Project	IEEE 802.16 Broadband Wireless Access Working Group <a href="http://ieee802.org/16">http://ieee802.org/16</a> Corrections to STC transmission in OFDM PHY  Initial: 2004-11-01			
Title				
Date Submitted				
	Revision 1: 2004-11-12			
Source(s)	Atul Salvekar mailto:atul.a.salvekar@intel.com Baraa Al-Dabagh mailto:baraa.al.dabagh@intel.com Hassan Yaghoobi mailto:hassan.yaghoobi@intel.com			
	Intel Corporation CHP3-105 350 East Plumeria Dr. San Jose, CA 95134			
Re:	Supporting document for call for contribution for corrigendum document			
Abstract	In P802.16 REVd/D5 [1], an STC Preamble is only mandatory if there is an STC allocation in the frame. However, in order to get accurate maintenance values, for example power, an additional precursor STC preamble should occur in a preceding frame. In order to alleviate the situation, it is recommended that if there is an STC allocation in frame K and there is no STC allocation in the preceding frame, K-1, then the BS must transmit an STC preamble as the last allocation in the preceding frame, i.e. frame K-1. The issue becomes even more severe in mobile situations where the channel variations can occur more rapidly. A second recommenda

Figure 2: Instability caused by using a single STC preamble for STC data transmission.

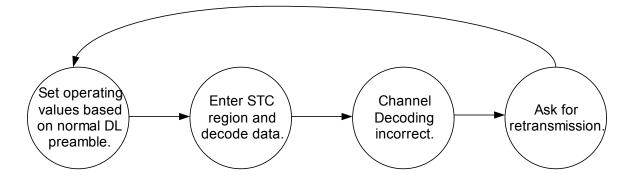
Suppose that during non-STC portions of the frame, the BS transmits on antenna 1. The SS sets operating values based on the DL preamble. Once STC enabled transmission begins, both antenna 1 and antenna 2 transmit, which may make these operating values faulty. This can result in incorrect decoding of the data. For instance the power from a single antenna could be over 20 dB less that that of a second antenna for uncorrelated Rayleigh Fading Channels. In this case, instability can exist as expressed in Figure 1.

Figure 3: New STC Frame structure in TDD

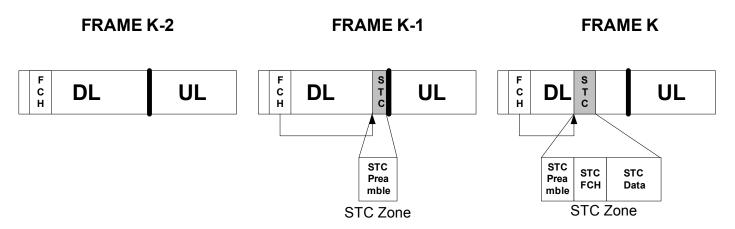
Thus, we suggest that in the case that there is STC encoded traffic in a specific frame, K, without STC encoded data traffic on the previous frame, K-1, the preceding BS DL subframe, K-1, contain an STC zone, in which the STC zone consists of only an STC preamble and with no FCH-STC, DL-MAP and STC data. The SS will be able to determine that there is no STC data allocation in frame K-1 STC Zone by determining that there has been no STC zone in the previous frame K-2. This is expressed in for TDD transmission in Figure 2.

The STC zone starts from a preamble and an STC encoded FCH-STC burst, which is one symbol with the same payload format as specified in Table 239-xxx. The FCH-STC burst is transmitted at BPSK rate ½. It is followed by one or several STC encoded PHY bursts. The first burst in the STC zone may contain a DL-MAP applicable only to the STC zone. If DL-MAP is present, it shall be the first MAC PDU in the payload of the burst. The DL map if sent in Burst 1 of the normal frame shall not describe any allocations in the STC region. In the case that there is an STC encoded traffic in a specific frame, K, without STC encoded data traffic on the previous frame, K-1, the preceding DL subframe, K-1, shall contain an STC zone at the end of the subframe, in which the STC zone consists of only an STC preamble without FCH-STC, DL-MAP and STC data. The SS will be able to determine that there is no STC data allocation in frame K-1 STC Zone by determining that there has been no STC zone in the previous frame K-2.

Figure 4: STC FCH

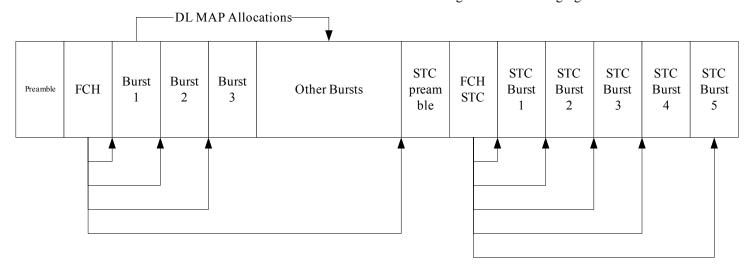
Since a downlink map may be sent in both the normal and STC section of a frame there can be a confusion on where should the STC allocation shall be spelled out. Thus we propose that the following be adopted: The FCH STC shall be changed in format to look like the normal FCH DLFP IEs with the restriction that there cannot be another STC region. The following figure illustrates that.

Syntax	Size	Notes
STC_DL_Frame_Prefix_Format() {		
for (n=0; n < 5; n++) {	4 bits	
Rate_ID/ DIUC		For all IEs this field is DIUC that defines the burst profile of the corresponding burst.
Preamble present	1 bit	If '1', preamble is placed before the burst.
Length	11 bits	Number of OFDM symbols in the burst.
}		
HCS	8 bits	An 8-bit Header Check Sequence; calculated as specified in Table 5
